Report to Development Permit Panel

File: DP 15-696896

Re: Application by McDonald's Restaurants of Canada Ltd. for a Development Permit
at 7120 No. 3 Road

5 PERMEABLE PAVERS WITH CONCRETE BAND
LP2 N.T.S.

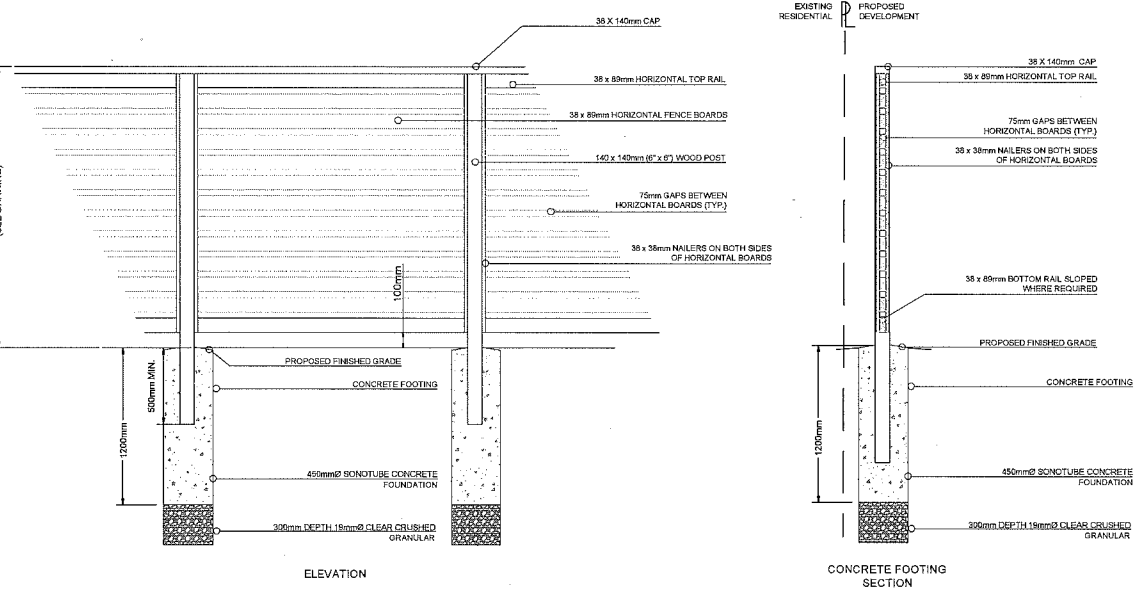
- agree with comment to reconsider stamped asphalt paving on the driveway; consider introducing concrete unit pavers;

Permeable pavers have been added for the parking stall areas in the front parking area complete with concrete banding as shown on the site plan. As noted on the detail on L2, two colours of pavers are proposed – one for the field and one to delineate the parking stall lines. The balance of the front parking area is a truck route so we have retained the heavy duty asphalt paving. In addition, the loading area has been changed to stamped concrete and will match the raised pedestrian connection.
